TSSS Pape

Project No.	2520	Addendum No.	02
Date	27 August 2026	Pages	3
Location	1076 Pape Ave, Toronto, ON

SCALE:	DRAWN:
INDICATE	CIA
DATE:	CHECKED:
MARCH 1990	
PROJECT NO.:	DRAWING NO.:
1 - 800 - 1	A - 8

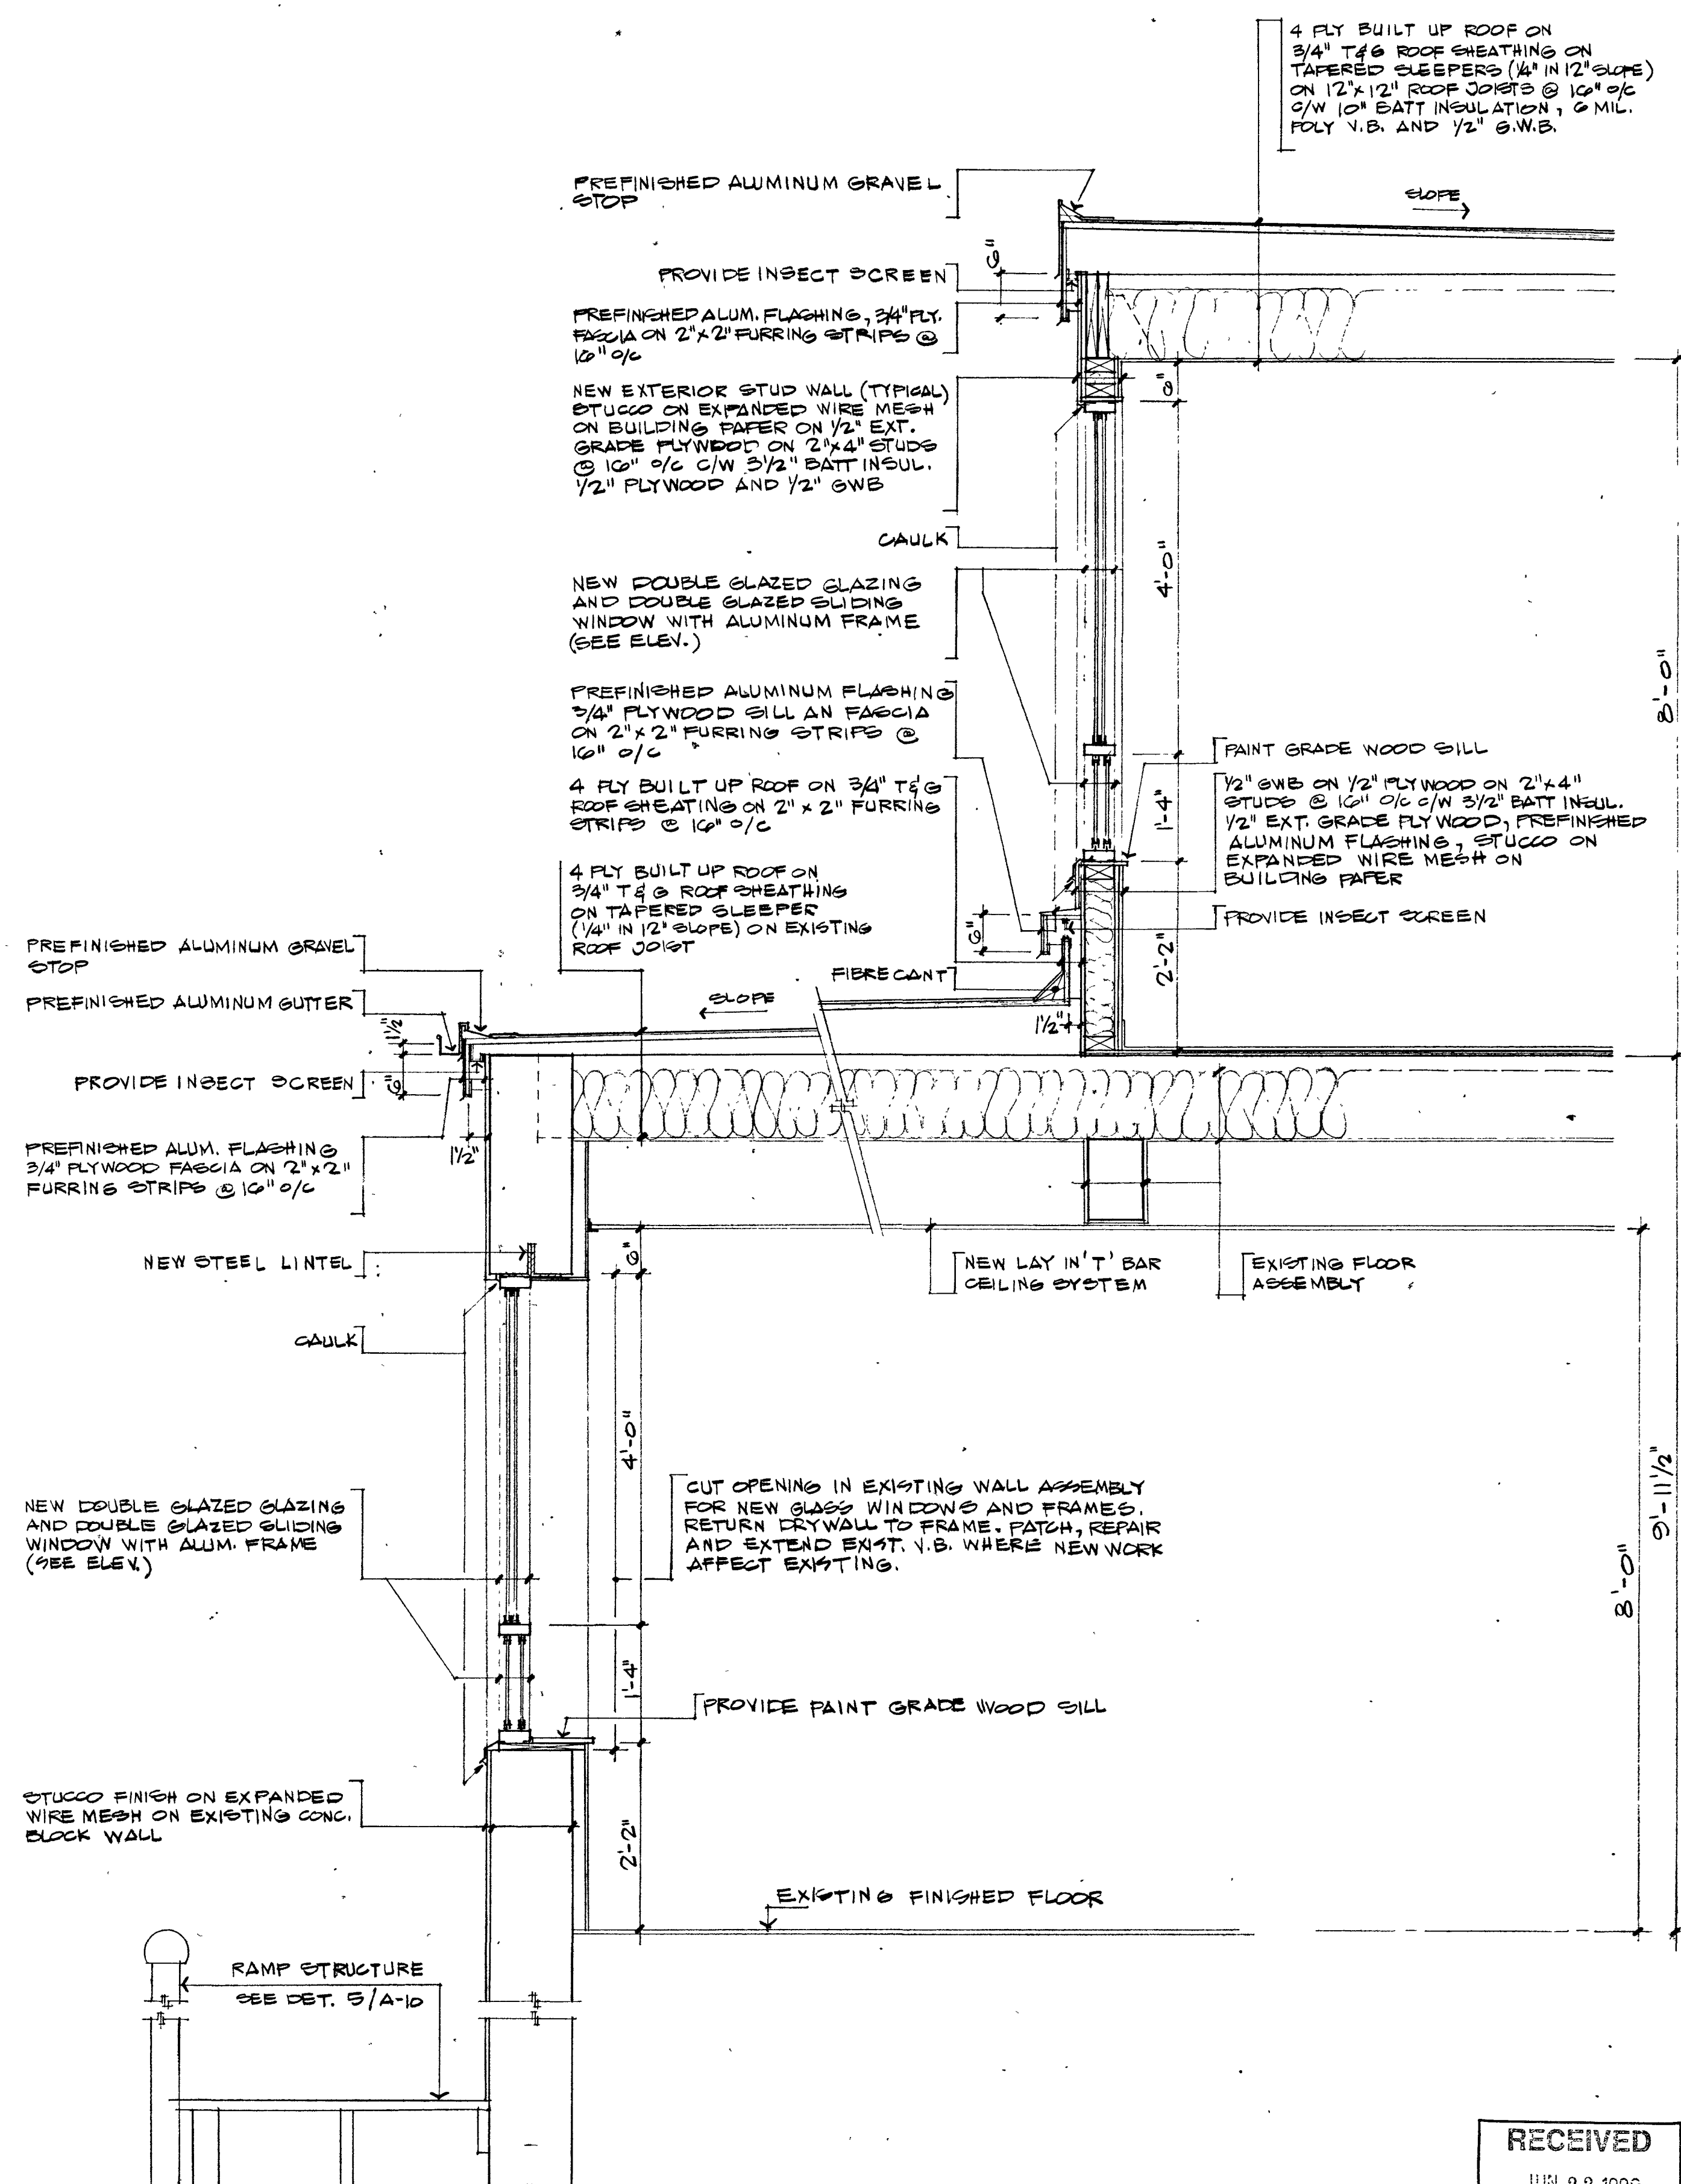
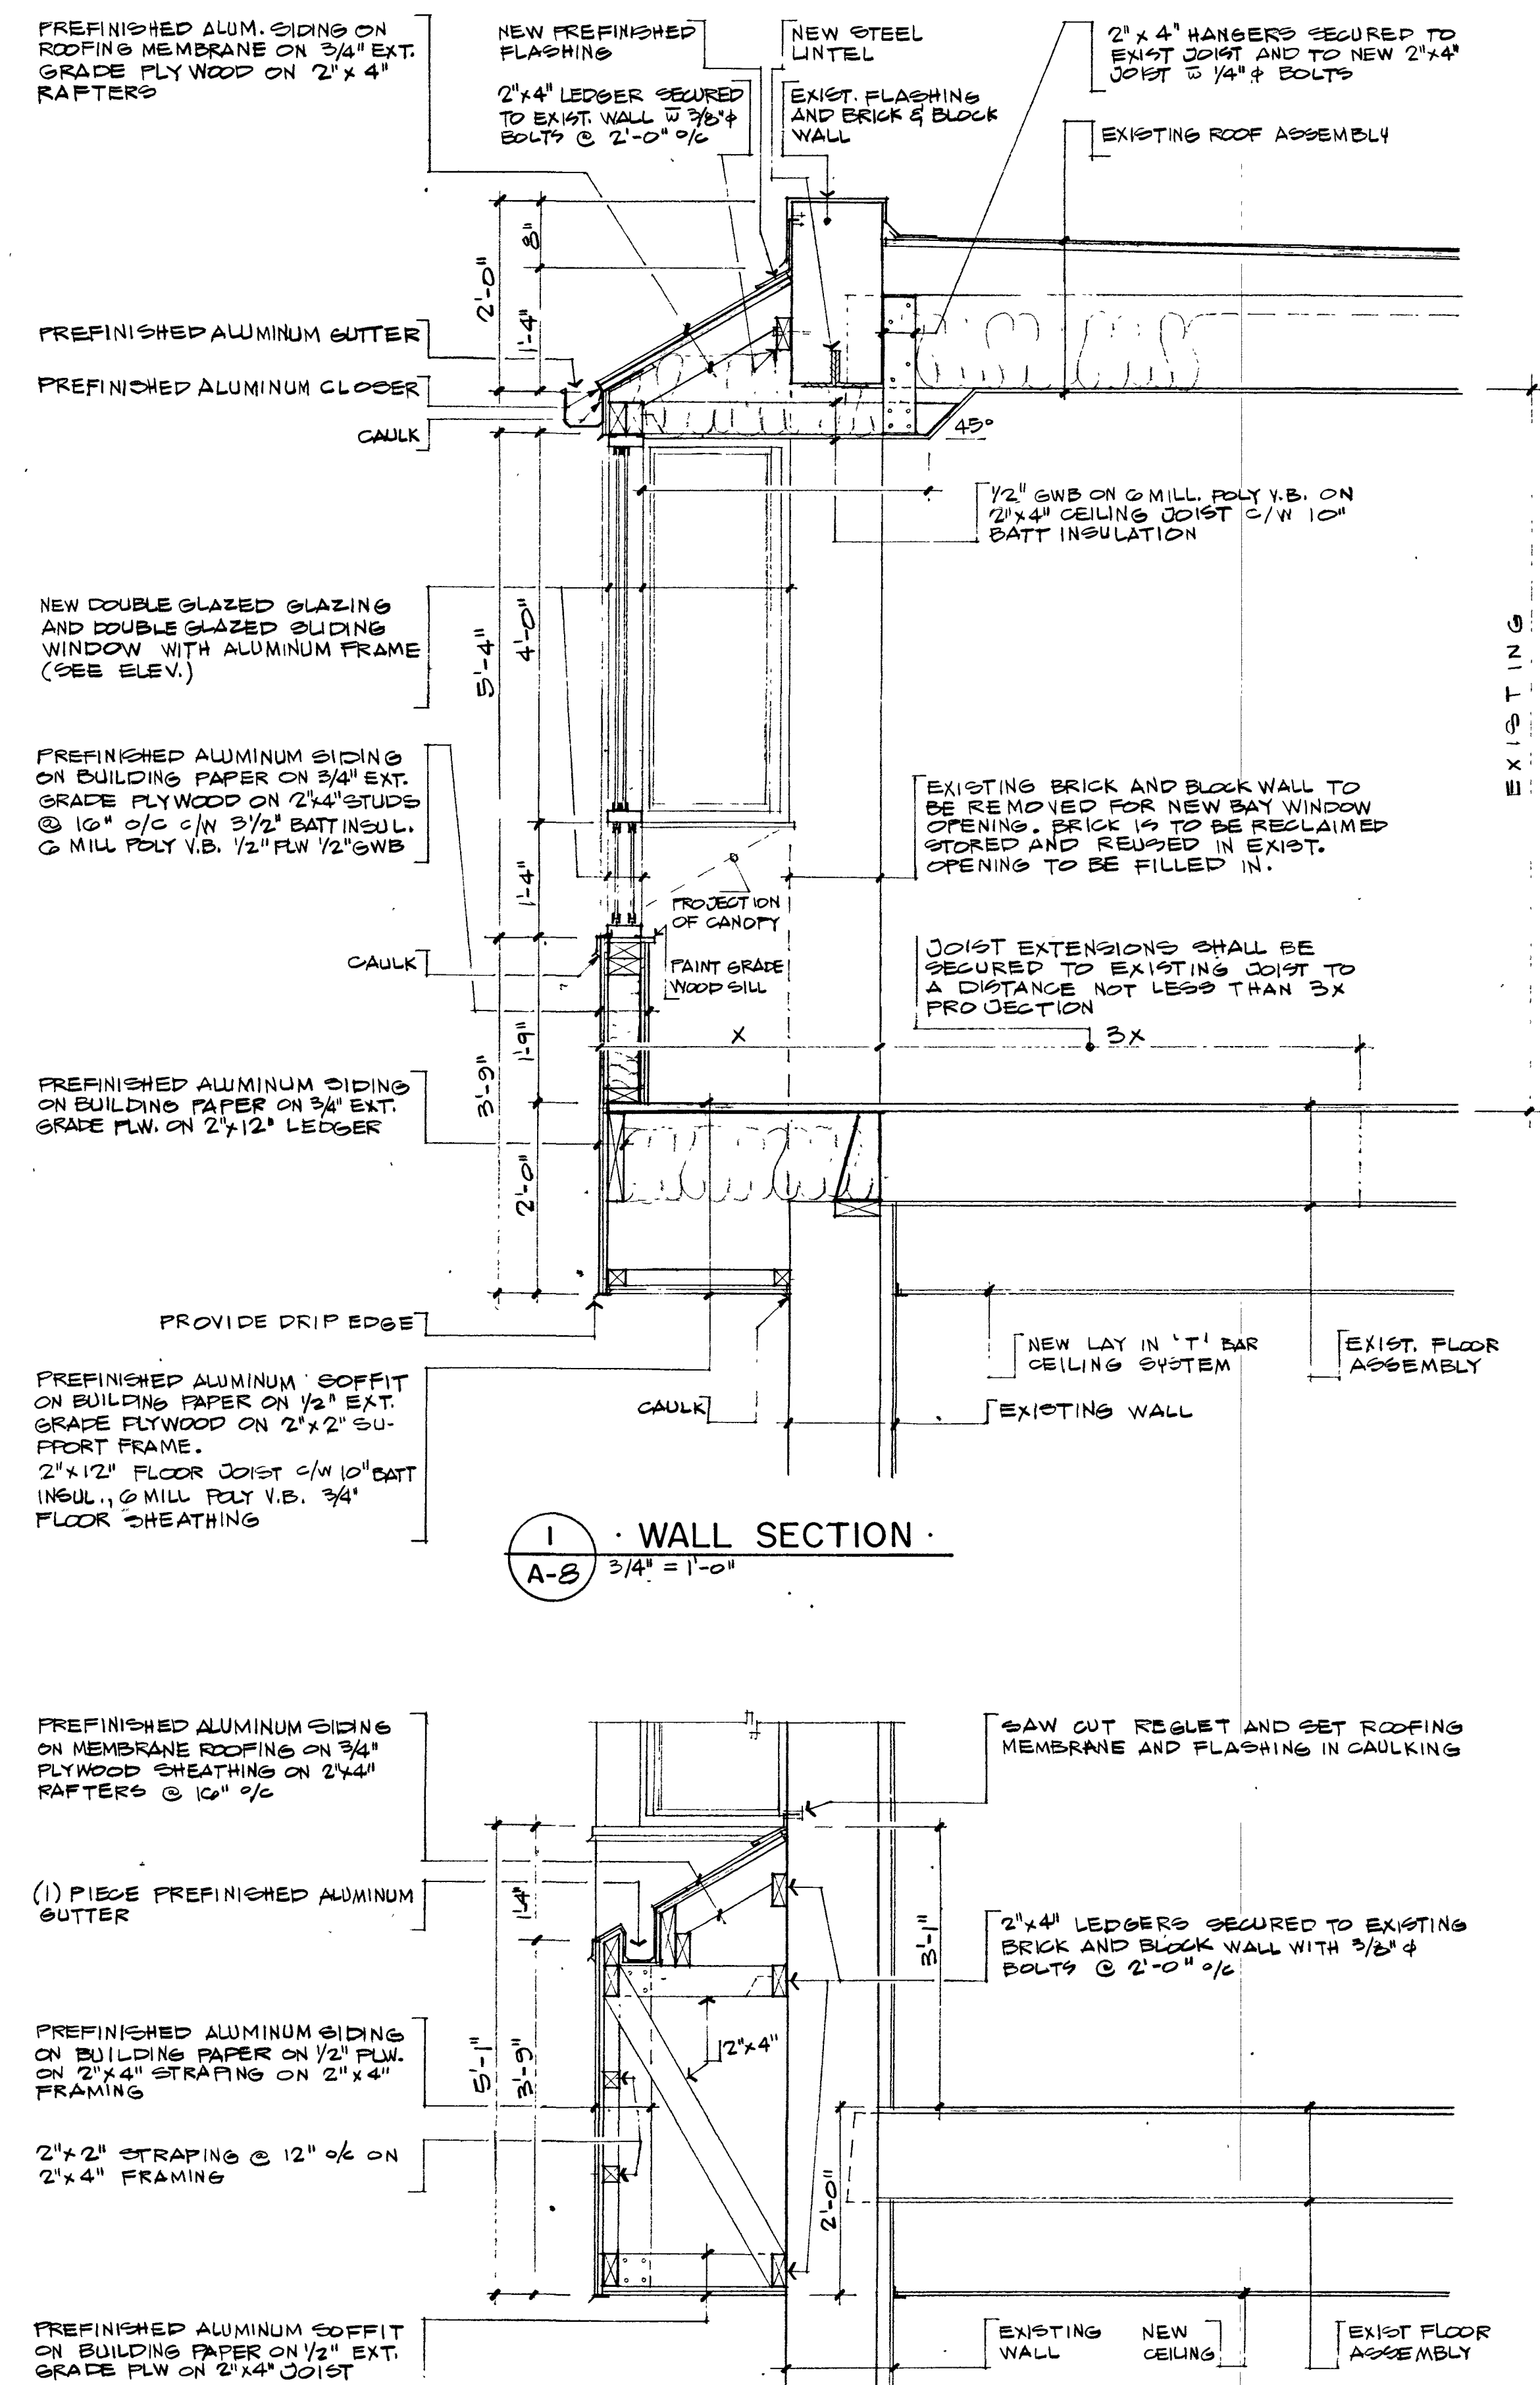
| 1. | Question: Please also provide existing roofing system composition/build-up. |

| | Answer: Please see attached existing building drawings A-4 & A-8. |
